Rahman Knit Garments Ltd.

Hariharpara, Panchabati, Fatullah, Narayanganj
(23.63014, 90.48090)

30th December 2020 & 24th January 2021.

Observations

COLUMN SCHEDULE

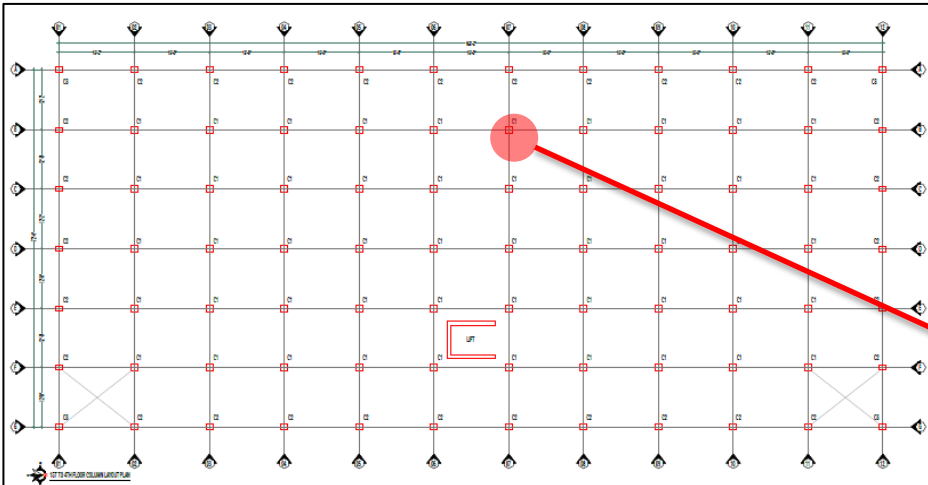
16 numbers of rebar shown in as-built column schedule for column C1.

14 number of rebar was found for the column C1 instead of 16 number rebar.

Factory engineer is required to survey the whole structure and update the as-built drawing as per on-site condition. Also, review the column stress according to the floor capacity.

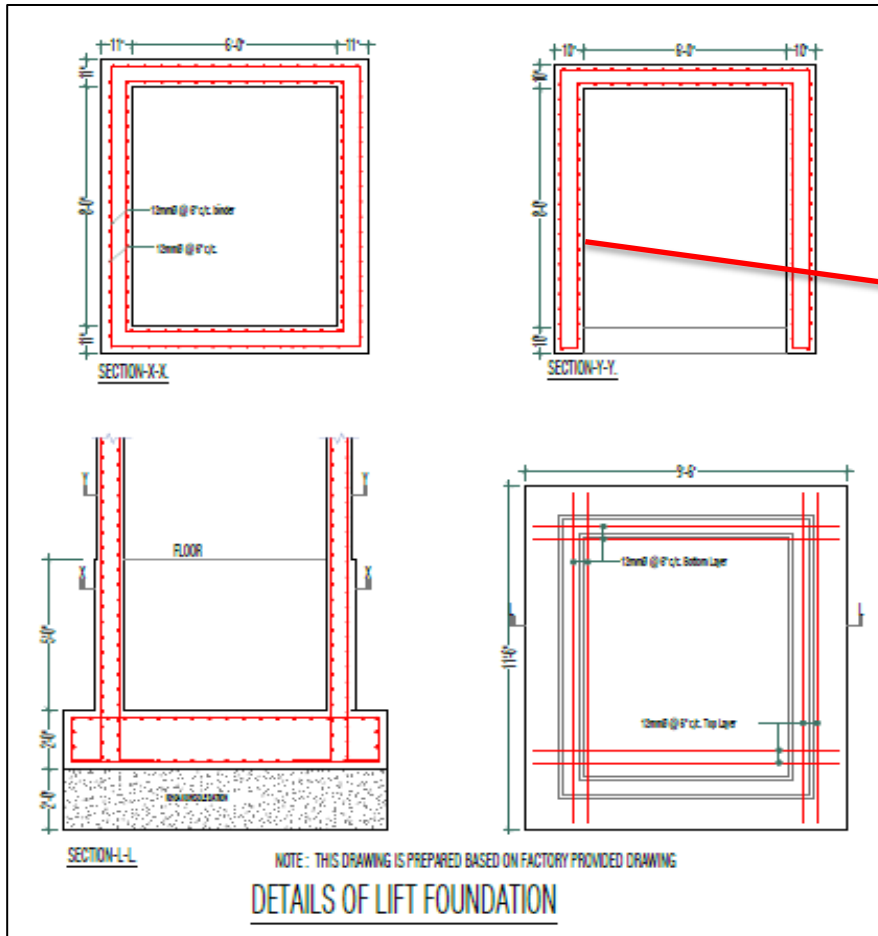
Cantilever slab was found in highlighted periphery areas measured 1.42m on site but dimension was not mentioned in as-built drawing. Factory engineer is required to survey the whole structure and update the as-built drawing as per on-site condition.

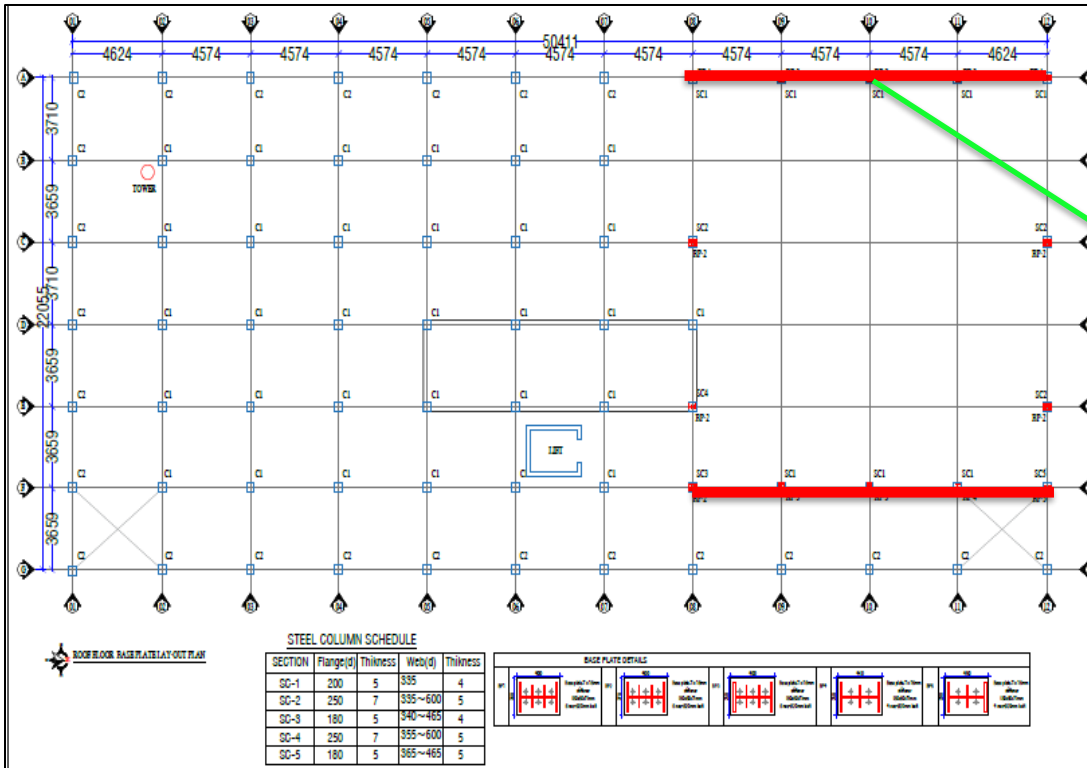
Thickness of highlighted RC shear wall at lift core found 200 mm instead of 250 mm. Factory engineer is required to survey the whole structure and update as-built drawing as per on site condition.

Thickness of shear wall at lift core was mentioned 250 mm in as-built drawing.

Loose bracing in roof shed.

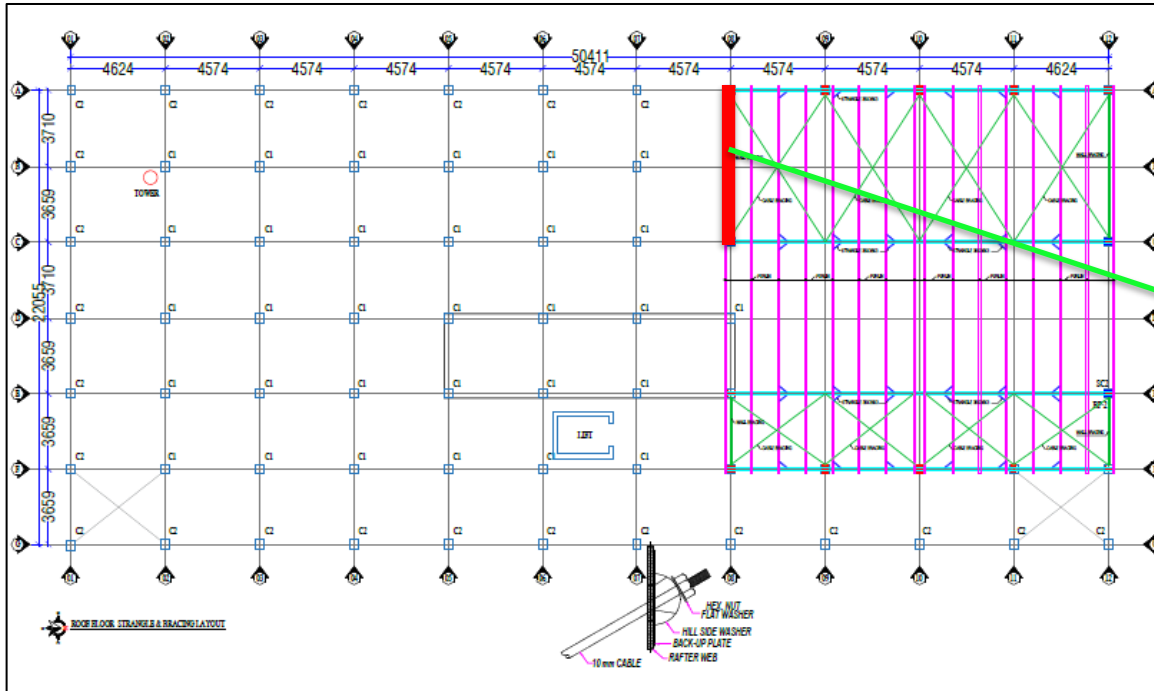
Wall bracing was found loose at highlighted location in roof shed. Factory engineer is required to survey the whole structure and tighten all loose bracings.

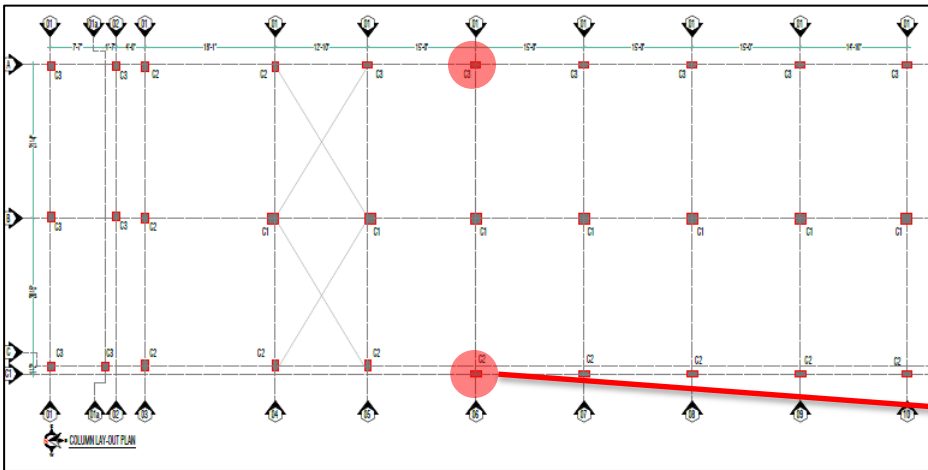
12 & 10 numbers of rebar shown in as-built column schedule for column C2 & C3, respectively.

8 & 6 numbers of rebar was found for the column C2 & C3, instead of 12 & 10 number rebar, respectively.

Factory engineer is required to survey the whole structure and update the as-built drawing as per on-site condition. Also, review the column stress according to the floor capacity.

Second floor Beam layout

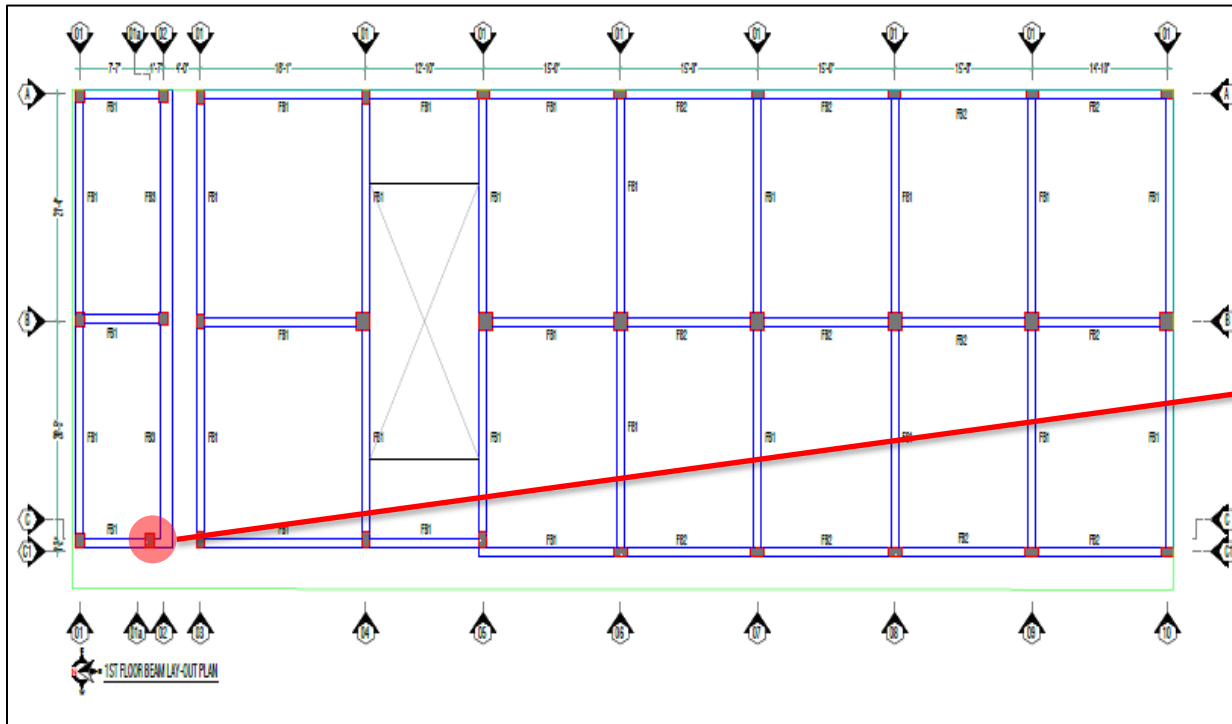
Beam width measured 275 mm

Width of Floor Beam FB3 was found 275mm instead of 375mm. Factory engineer is required to check the adequacy of highlighted beam under existing loading and update the as-built drawing as per on-site condition.

Eccentric connection

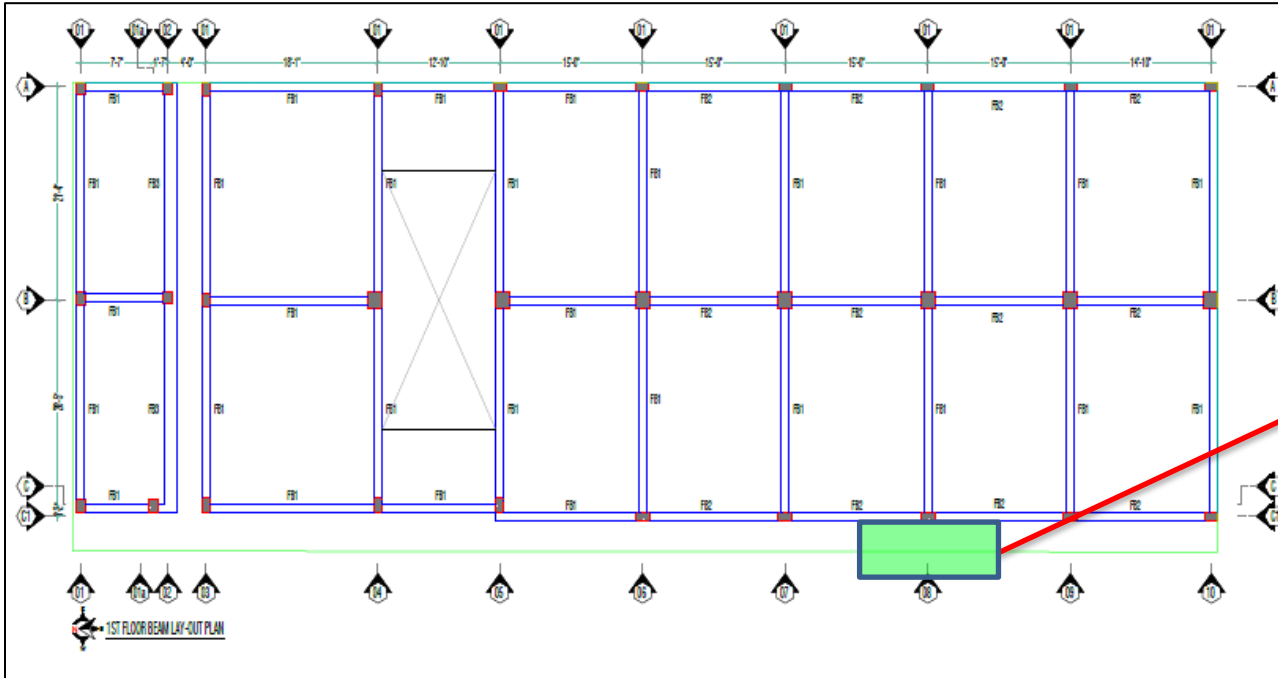
Eccentric connection was found in highlighted location of the building where beam is resting outside of column which indicates the irregularity in load transfer system. Factory engineer is required to check the adequacy of highlighted beam under existing loading and update the as-built drawing as per on-site condition.

Cracks in beam and slab

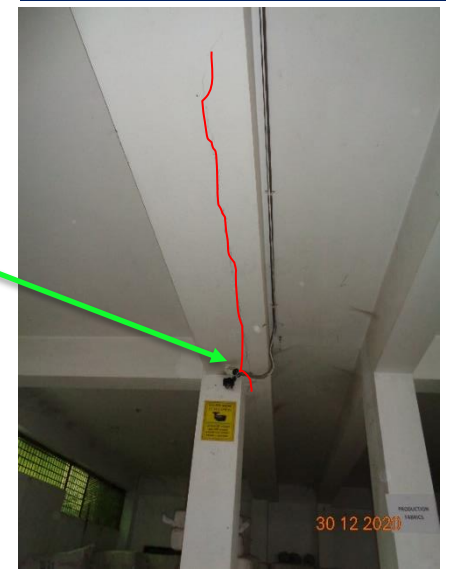
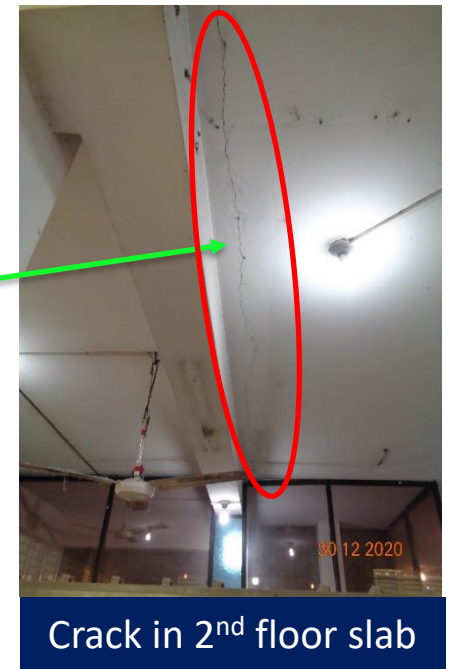
Crack was found in second floor slab and first floor beam. Factory engineer is required to investigate the cause of crack and repair the crack with a suitable method.

Column layout (cracked column is marked)

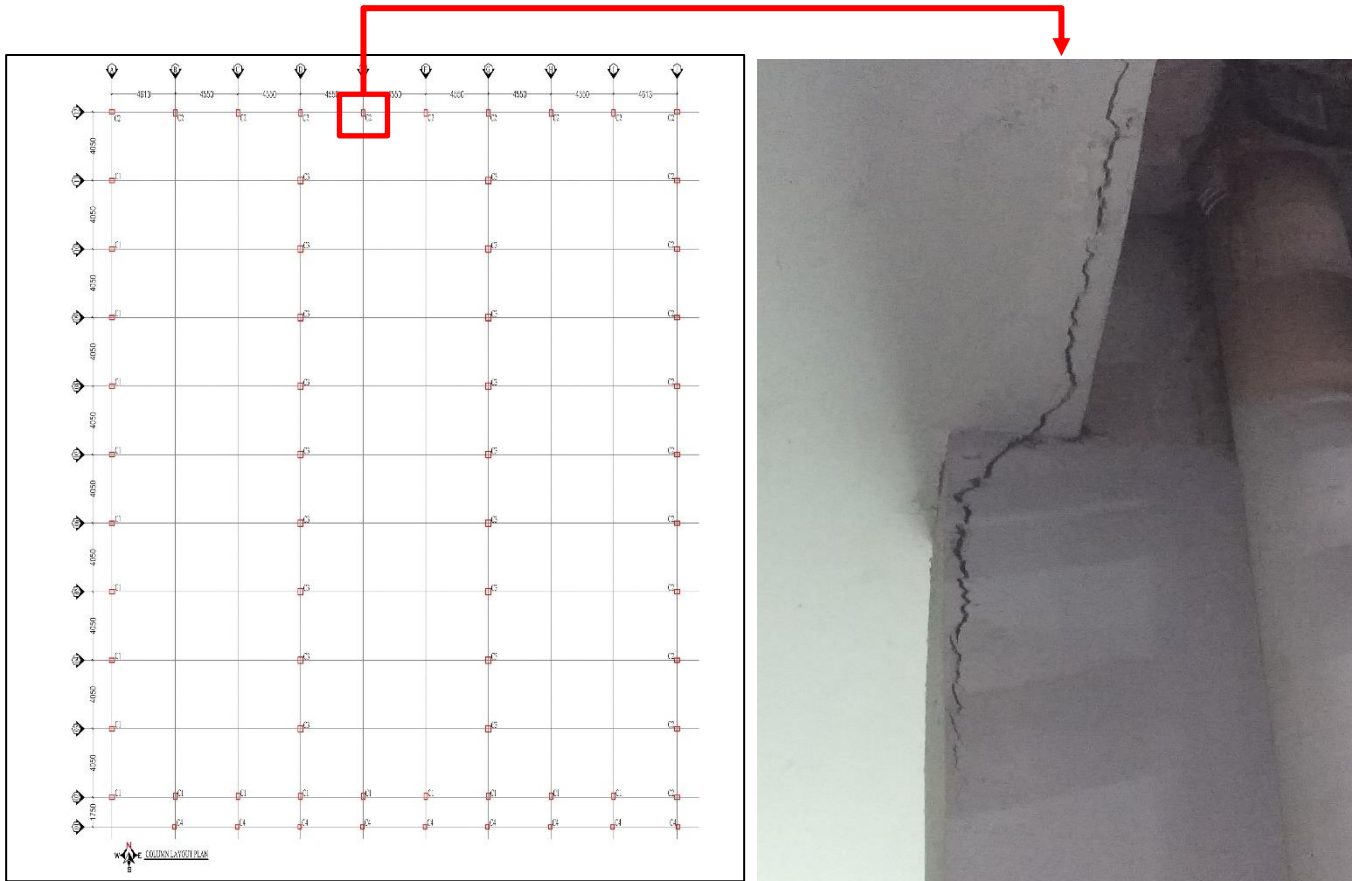
During inspection, marked column was found cracked on the surface. Upon breaking it was revealed that the crack extends up to rebar. Factory engineer is immediately required to investigate the cause of crack and repair the crack with a suitable method.

Roof purlin layout plan

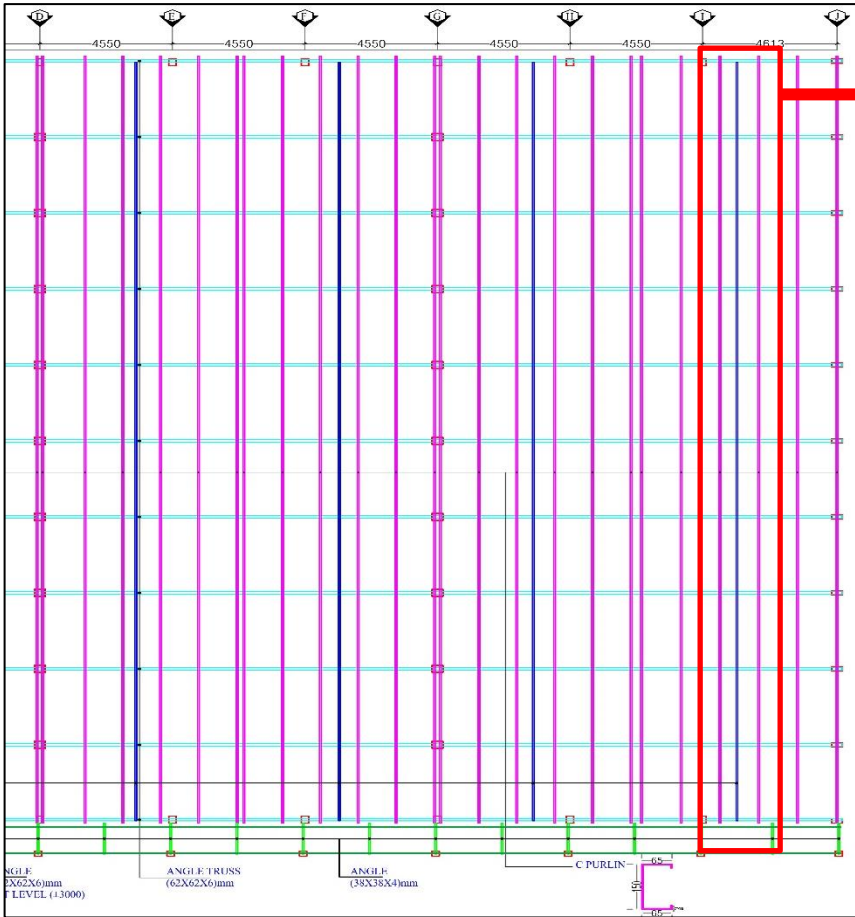
Compression strut marked in the picture

The trusses are connected with one another by compression struts only along long direction and roof bracing is not provided therefore lateral stability system along long direction appears to be weak. Factory engineer is required to check the lateral stability of the shed against all lateral loading.

Purlin and roof cable bracing layout

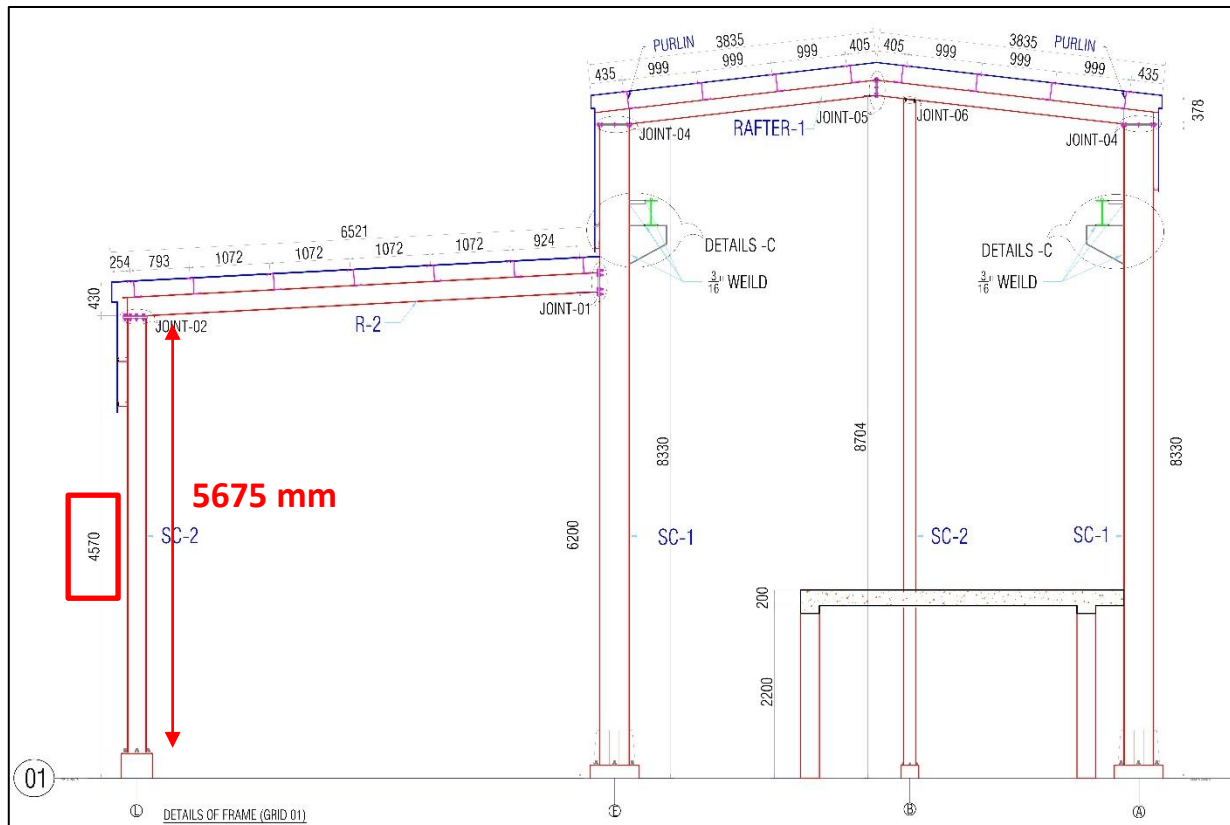
Roof bracings were supposed to be between gridline 4 and 5 as per as built drawings but during inspection cable bracings were found between gridline 5 and gridline 6. Also, bracings between gridline 7 and gridline 8 were missing. Factory engineer is required to check the lateral stability of the shed considering the discrepancies and update the as-built drawing as per on-site condition.

Missing beam

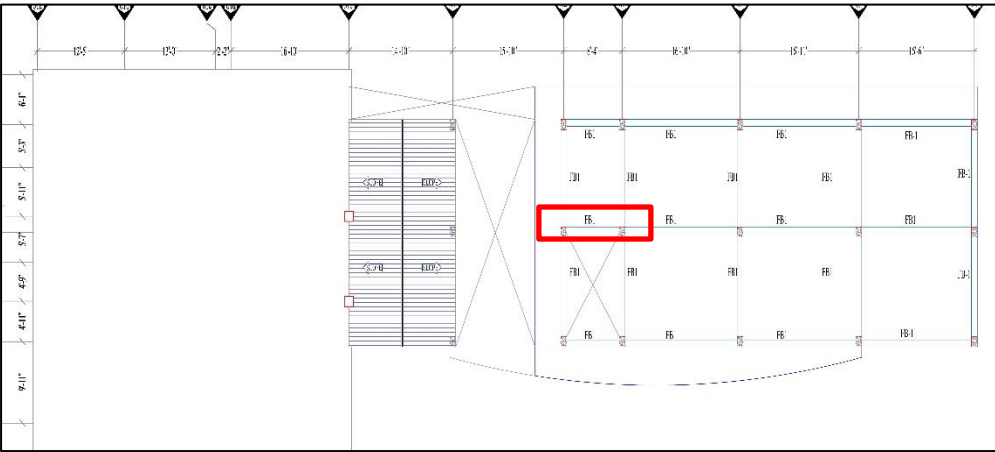
Marked beam in the 2nd floor beam layout was missing onsite.

Marked beam in the 3rd floor beam layout was found missing onsite.

Some beams were missing physically at several locations which were shown in provided drawing. Factory engineer is required to survey the whole structures and produce as-built drawing for this structure. Also, review the adequacy of the structural system considering the missing beams.

Column Schedule

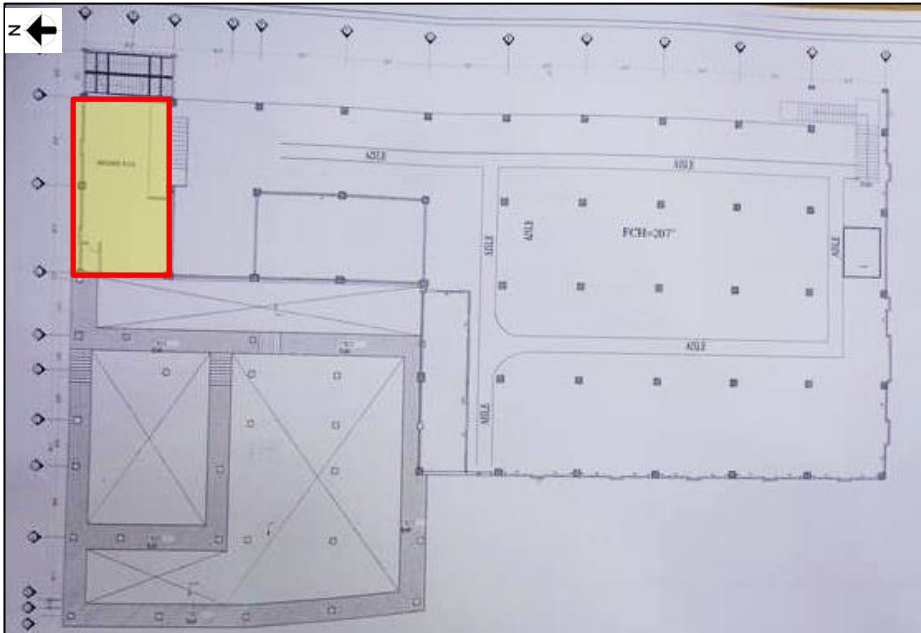
Column was found 600X400mm. Re-bar: #16Ø20mm

Column ID of highlighted columns is not mentioned in layout.

The columns of the marked locations (Rectangle) were only found at ground floor. These columns were not extended at upper floors. Also, columns at circular marked location was found 600X400 mm. Neither column ID for those columns shown in column layout nor dimension of those columns matched with any type of column shown in column schedule. Factory engineer is required to survey the whole structure and update as-built drawing as per onsite condition.

Mezzanine floor layout plan

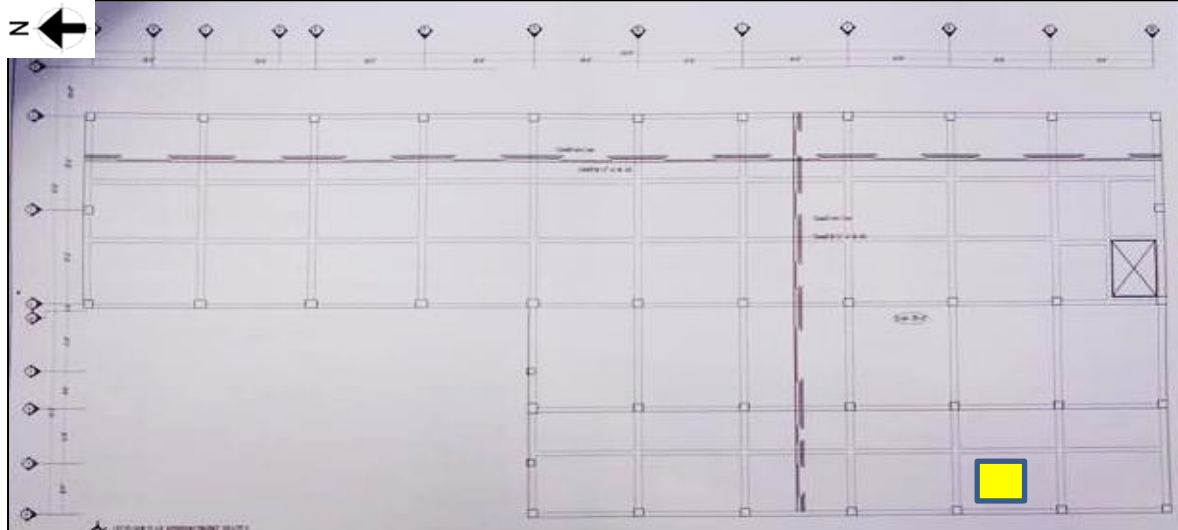
Mezzanine floor is supported by steel Beam and Column frame structure. But no structural information has been provided in drawing regarding this steel structure.

Factory engineer is required to survey the whole structure and update the as-built drawing.
